## Marquam Hill Connector

Working Group 4/25 Worksheet Input - DRAFT

After the April 17 working group, members were asked to fill out a worksheet to rank and provide input on the four connector types, based on the current information and discussion. Below is a compilation of these worksheets, which were turned in on April 25. This compilation represents a snapshot of feedback at that time and may not reflect future preferences based on new information. This feedback represents the views and opinions of working group members and does not reflect official organizational positions.

**Area of Disagreement: Landing Point**

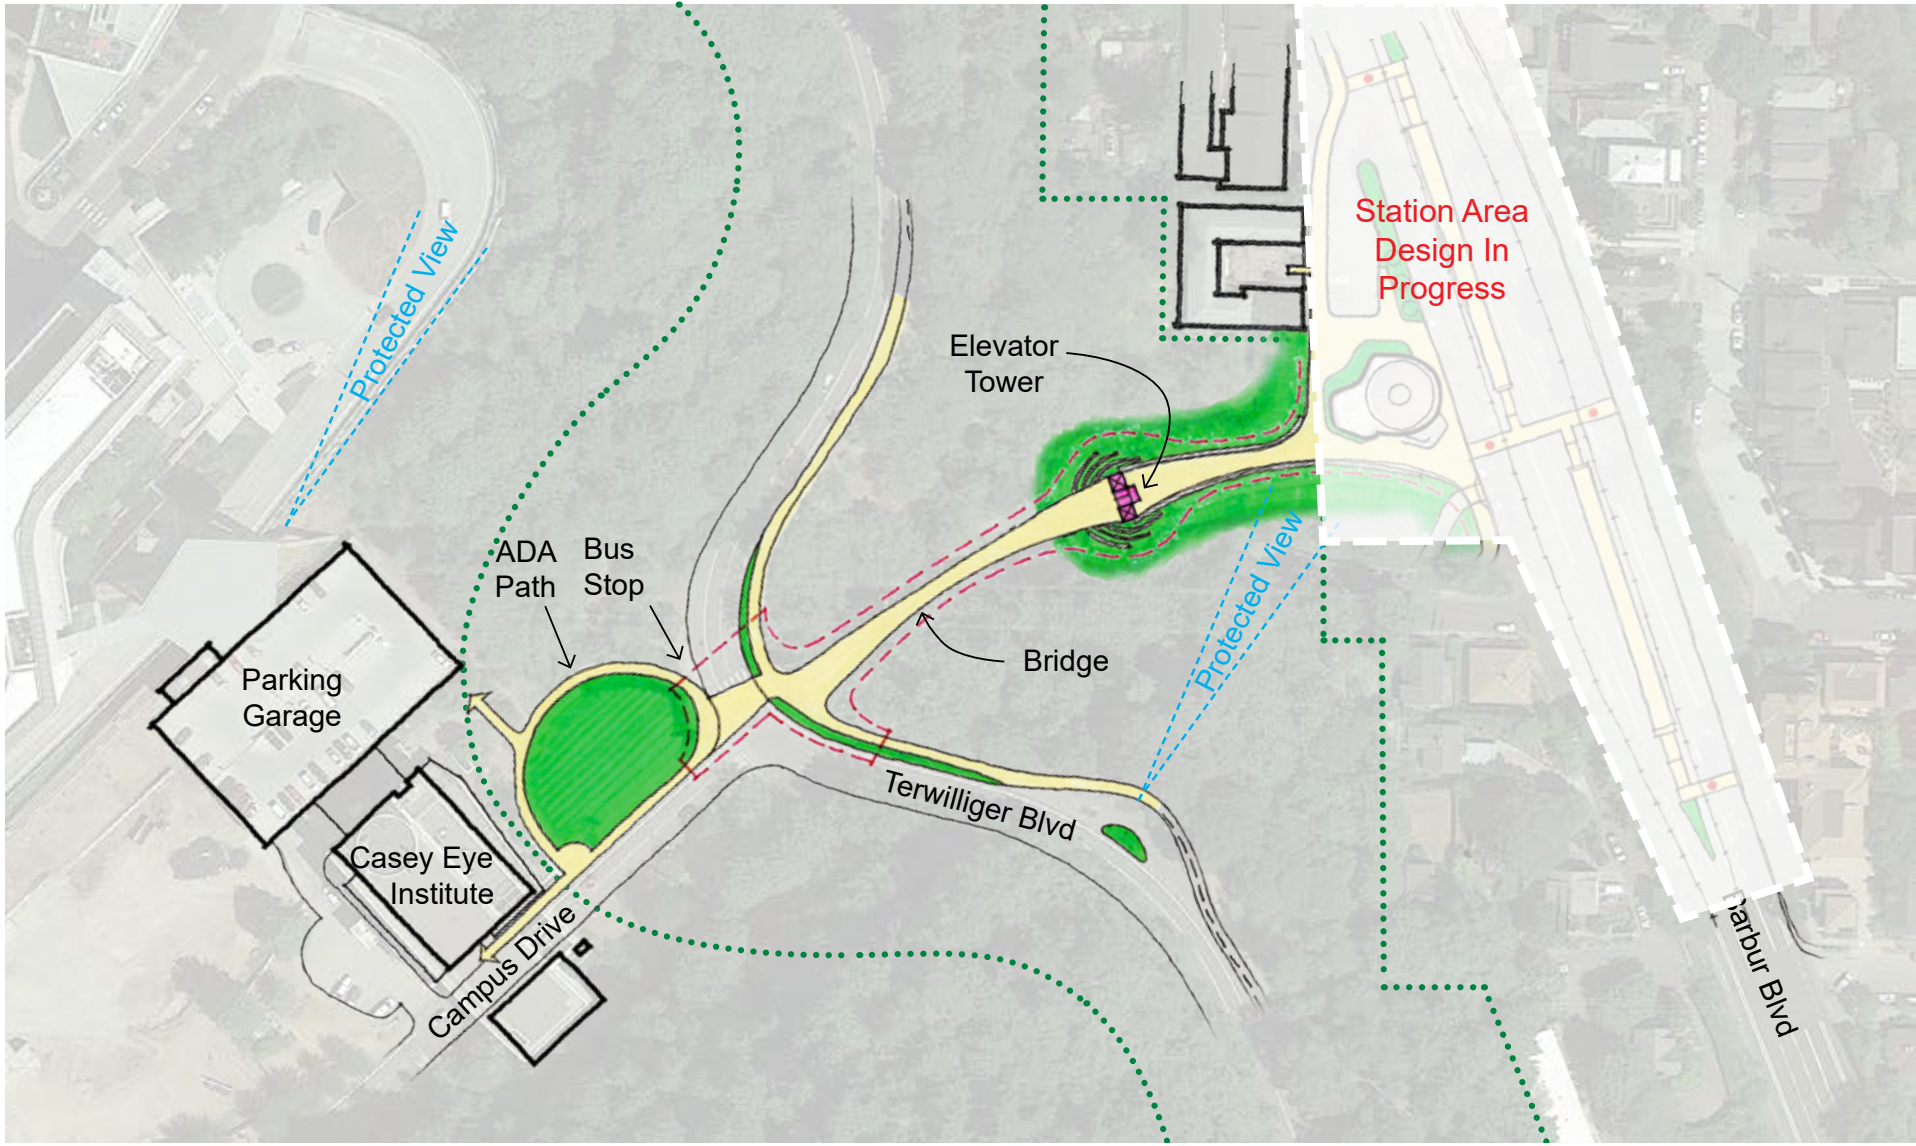
While there is considerable agreement about the preference for an inclined elevator, working group members' preferences for an upper terminus location are split, as reflected in the worksheets:

Terminus East of Terwilliger	Terminus West of Terwilliger
<ul style="list-style-type: none"> <li>Jeb Doran of TriMet</li> <li>Hillary Adams of BDS</li> <li>Michael Harrison of OHSU</li> <li>Brett Horner of PP&amp;R</li> <li>John Dodier of VA Hospital</li> </ul>	<ul style="list-style-type: none"> <li>Teresa Boyle of PBOT</li> <li>Don Baack of SW Trails</li> <li>Anton Vetterlein of Friends of Terwilliger</li> <li>Ed Fischer of Homestead NA</li> <li>Jim Gardner of South Portland NA</li> </ul>
Reasoning for Landing Choice	
<ul style="list-style-type: none"> <li>Minimizes cost</li> <li>Minimizes construction risks</li> <li>Improves at-grade crossing</li> </ul>	<ul style="list-style-type: none"> <li>Undercrossing reduces modal conflicts on Terwilliger</li> <li>Maintains historic character of Parkway</li> <li>Lands closer to Hill destinations</li> </ul>

## 2. Bridge/Elevator

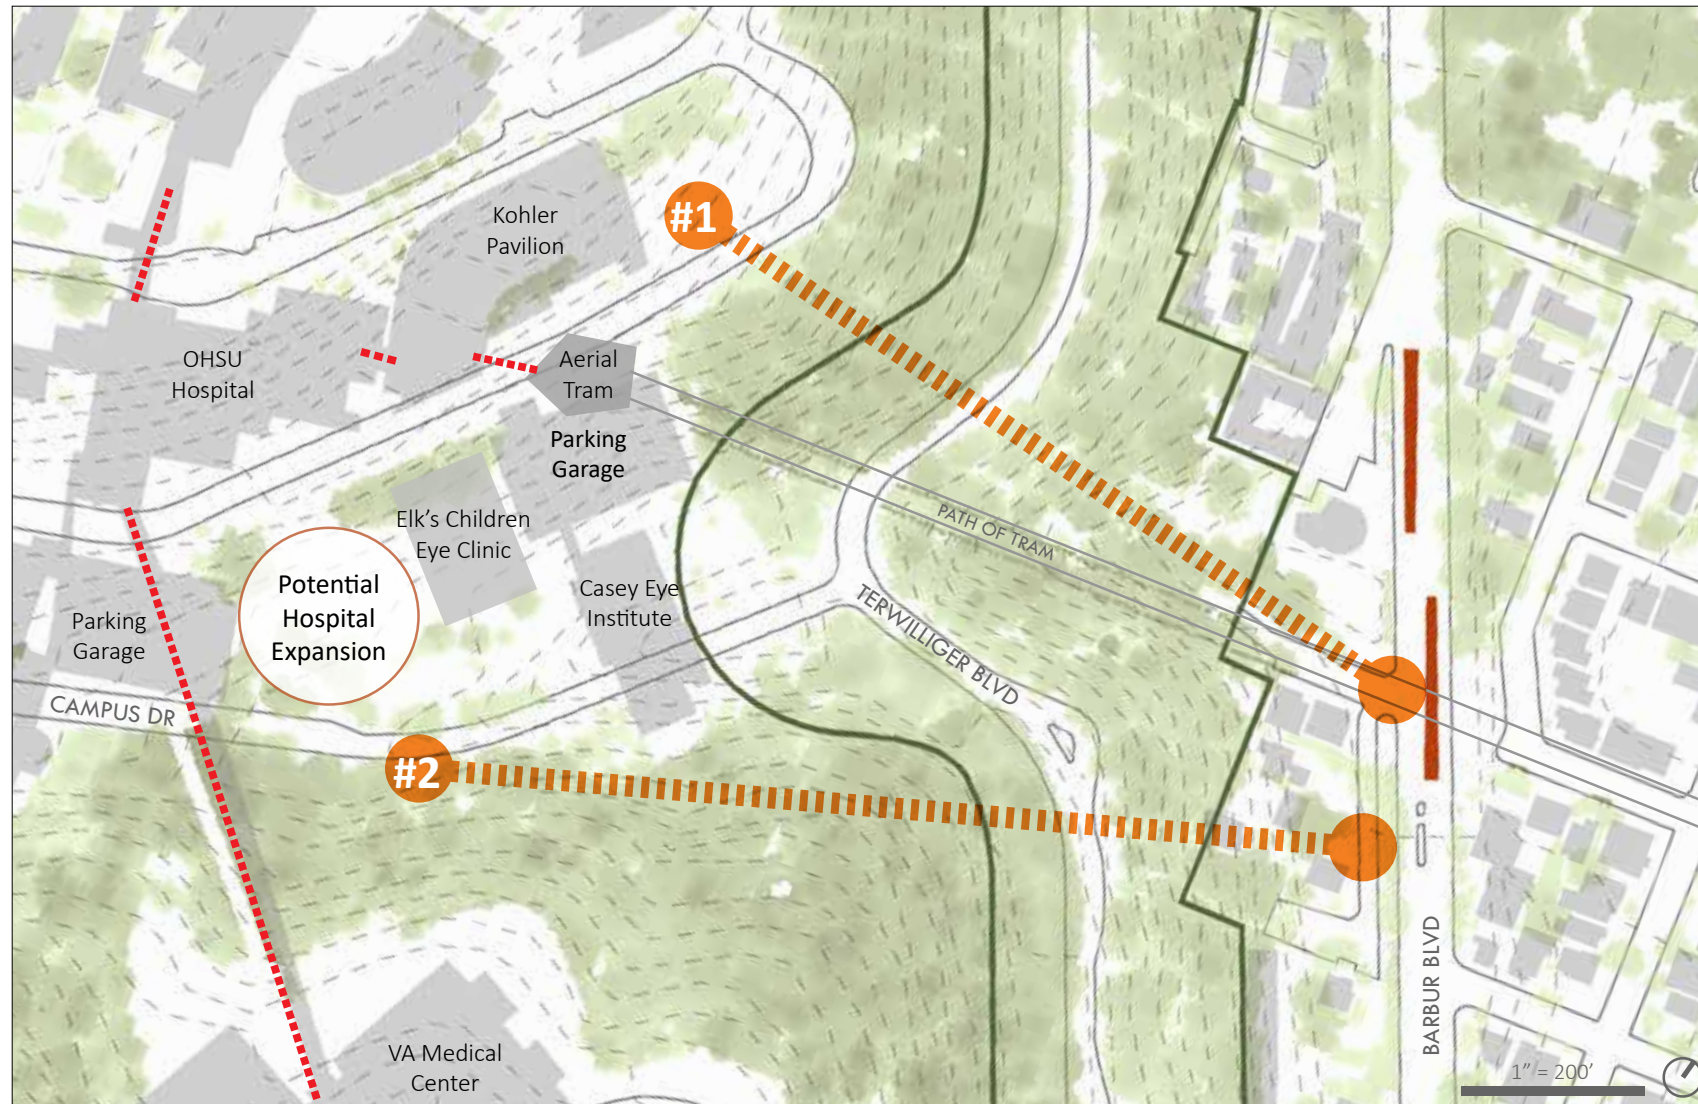
Pros	Cons
<p><b>Access</b></p> <ul style="list-style-type: none"> <li>• #8 bus connection</li> <li>• Parkway recreation and nature</li> <li>• Centralized dispersal point</li> </ul> <p><b>Budget (\$15 – 25 million)</b></p> <p><b>Operational</b></p> <ul style="list-style-type: none"> <li>• No attendant</li> <li>• Free</li> <li>• Likely to be 24/7</li> </ul> <p><b>Experience</b></p> <ul style="list-style-type: none"> <li>• Canopy walk</li> <li>• Views</li> </ul>	<p><b>Access</b></p> <ul style="list-style-type: none"> <li>• Walk distance, exposure on bridge</li> <li>• Requires additional connection into campus via pathway or bus</li> </ul> <p><b>Context</b></p> <ul style="list-style-type: none"> <li>• Size/visibility of elevator tower</li> <li>• Width/thickness/visibility of bridge structure &amp; abutment</li> <li>• View corridors</li> <li>• Tree clearing around bridge structure</li> </ul> <p><b>Safety</b></p> <ul style="list-style-type: none"> <li>• Camping under structure</li> <li>• At-grade xing - concerns about sight lines &amp; modal conflicts on Terwilliger</li> <li>• Bridge width – concerns about bike/ped conflicts</li> </ul> <p><b>Environmental</b></p> <ul style="list-style-type: none"> <li>• Tree removal</li> <li>• Potential impacts to utilities</li> </ul>

- Minimize footprint
- Restore viewpoints eastward
- Use architectural elements to blend with parkway & natural setting
  - Use thin profile structure
- Minimize removal of high value trees
- Tuck elevator tower into hillside/minimize bridge length
- Consider public stairway separate from elevator tower
- Construct in tandem with trail improvements
- Consider additional connection opportunities further west such as:
  - Better elevator access through OHSU buildings (CEI garage or hospital expansion)
  - Frequent circulating campus bus or shuttle

During working group discussions, there was varying opinions on whether the bridge should include weather protection. Some felt this was important, while others felt this would add to the visibility of the structure in the park.

Conceptual alignment #1 to Campus Dr/Sam Jackson Park Rd

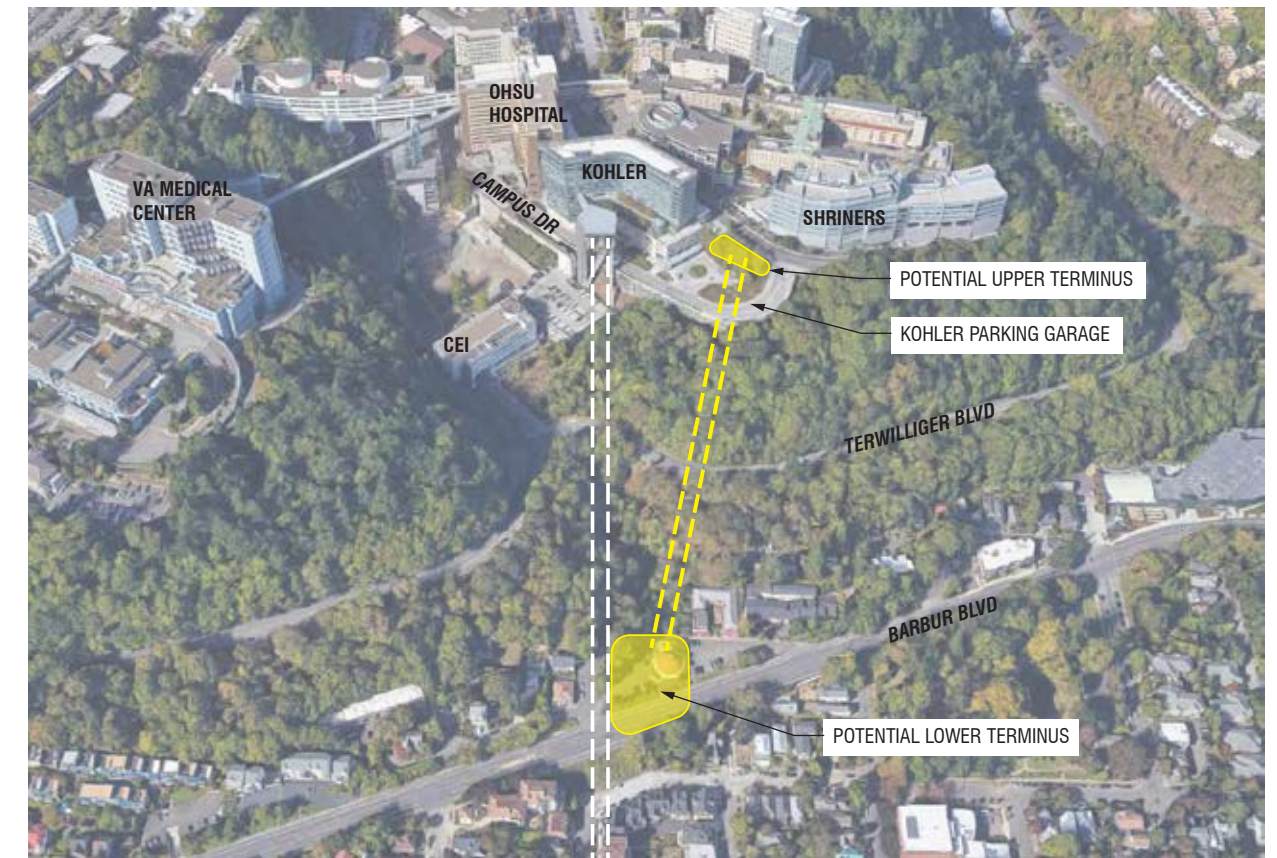
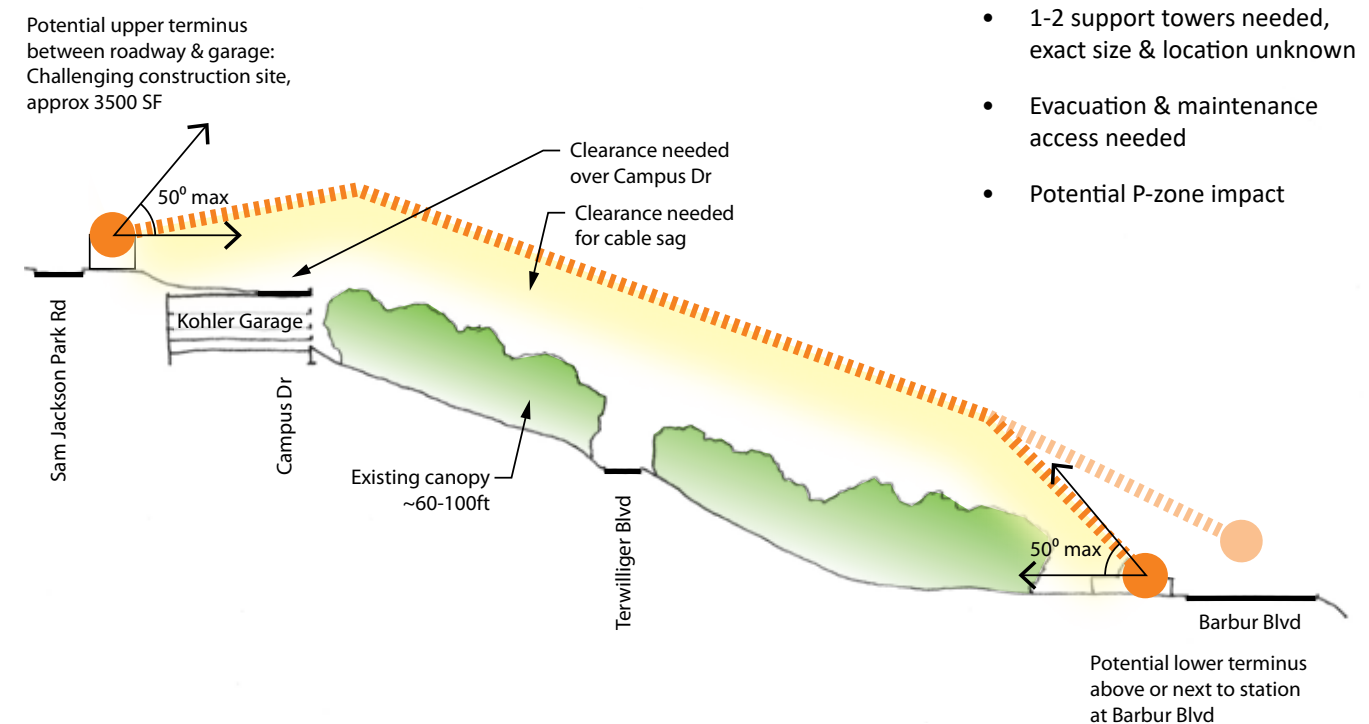
- 1-2 support towers needed, exact size & location unknown
- Evacuation & maintenance access needed
- Potential P-zone impact
